SUBJECT: Limerick Generating Station, Unit 2
 Technical Specifications Change Request

TECHNICAL SPECIFICATIONS CHANGE REQUEST

No. 92-07-2

"Proposed Changes to the Technical Specifications to
Relocate the Hydraulic Control Unit (HCU) Isolation Boundaries"

FIGURE 1

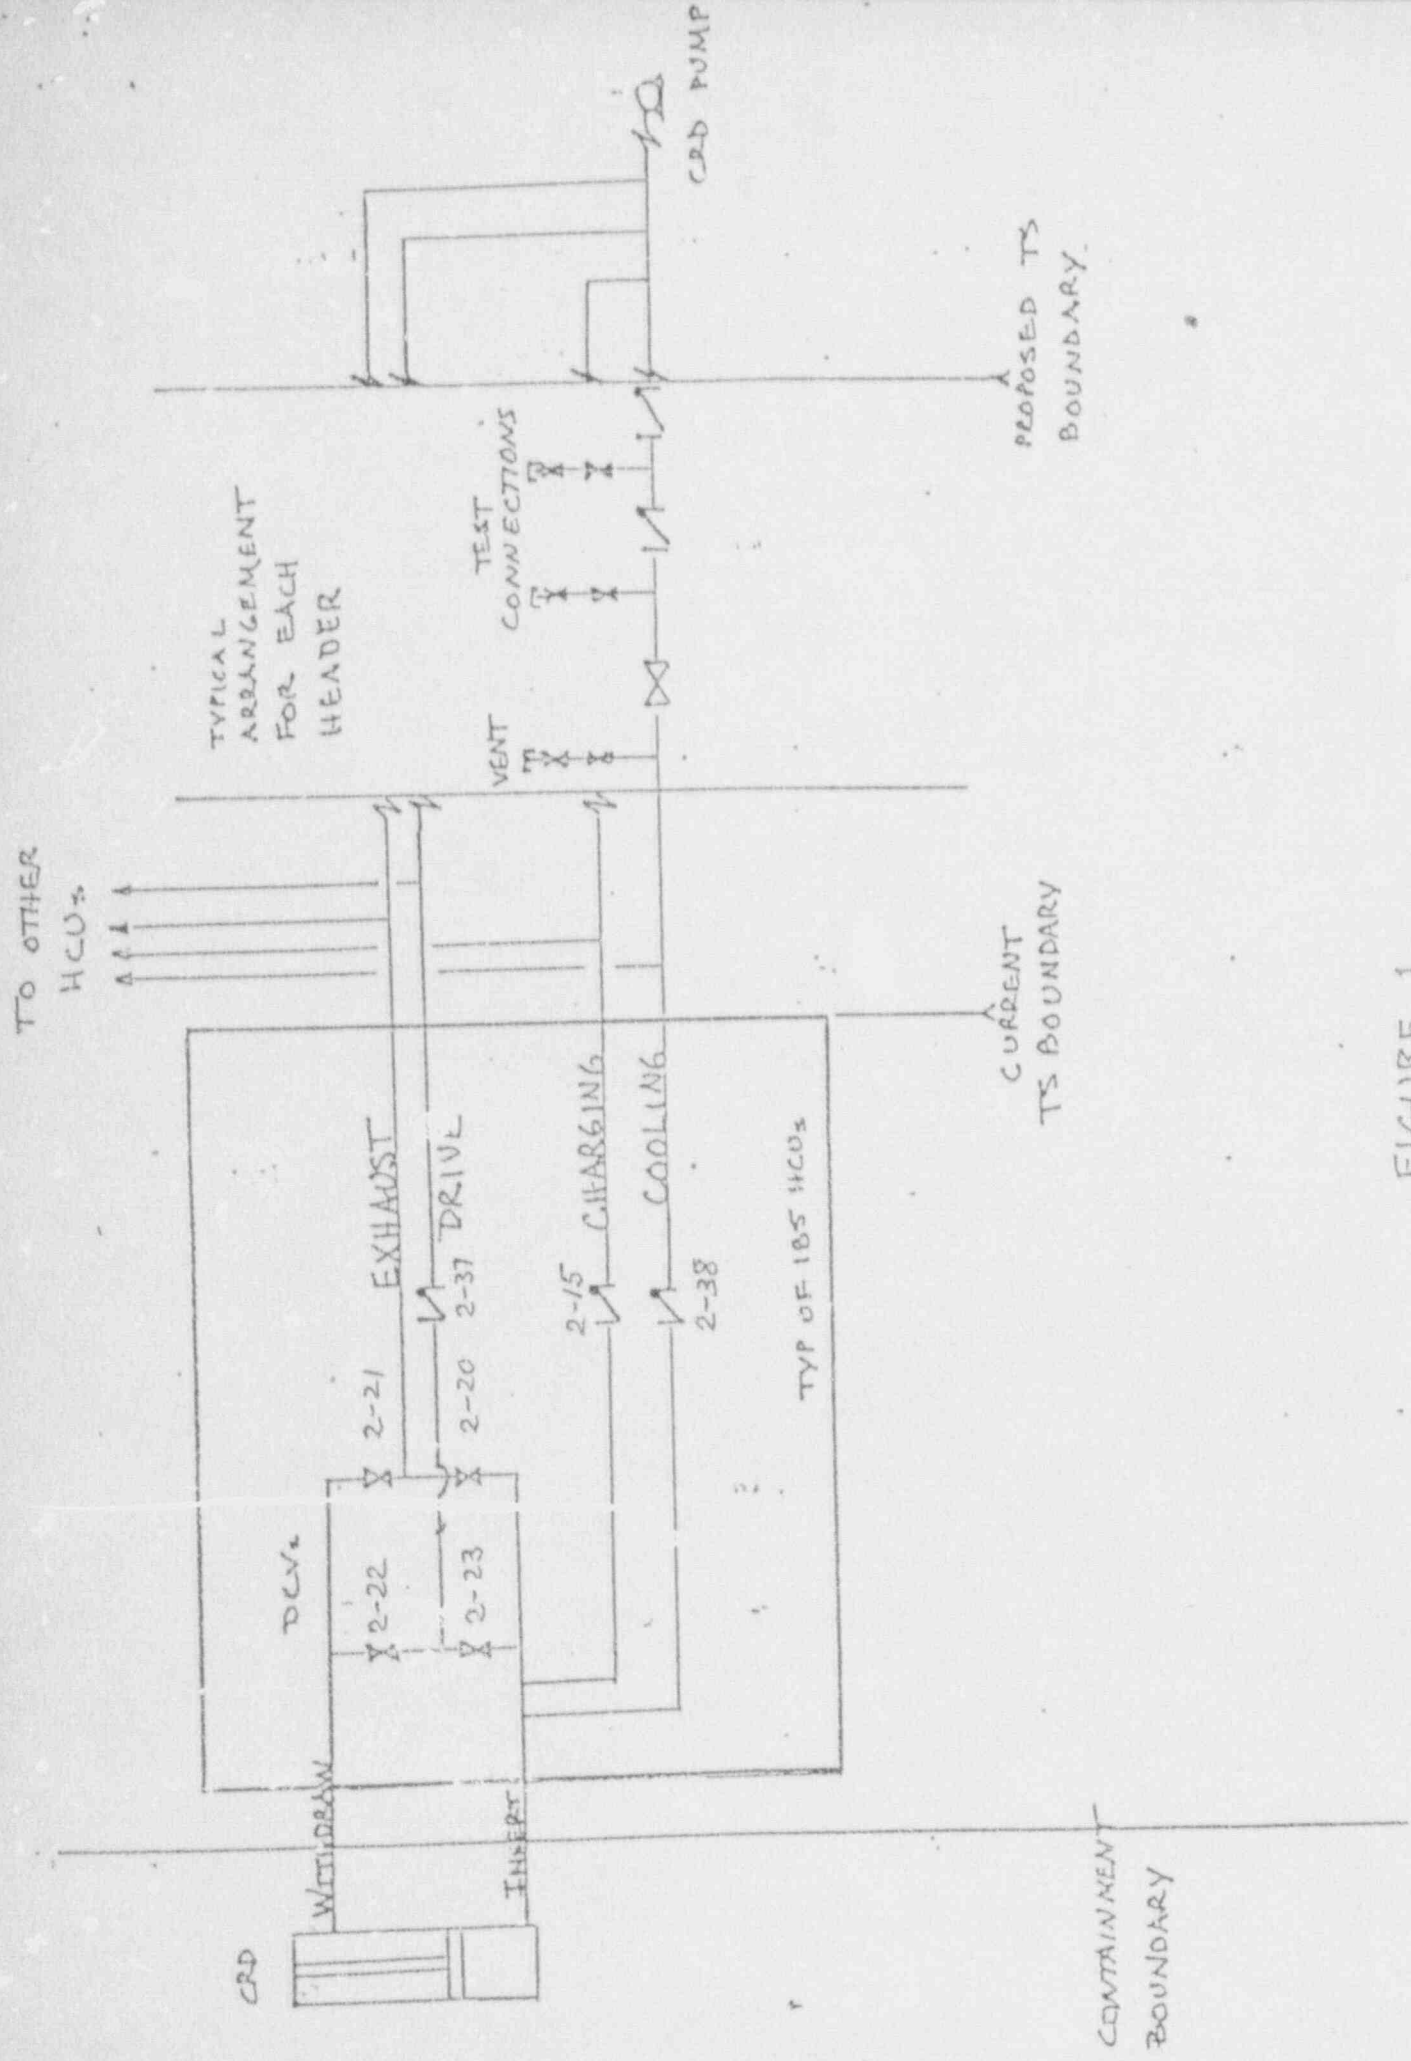
To minimize critical path outage time, new check valves will be installed in the CRD supply headers in four locations, effectively extending the isolation boundary from the HCUs to these new valves (See Figure 1). These four (4) new valves will reduce the number of testable CRD penetrations from approximately 1300 to four.

The proposed TS change will take credit for the new check valves installed in each of the CRD headers to the HCUs (i.e., drive, cooling, charging, and exhaust) between the main control station and the vent valve. These valves constitute a new isolation boundary. Each check valve station consist of two check valves, a block valve, and two test connections. This enables each check valve to be tested individually instead of during the critical path ILRT. A new access platform has been installed in order to facilitate local testing of the added check valves. The new platform was designed to the American Institute of Steel Construction (AISC) and Seismic Category 1 requirements.
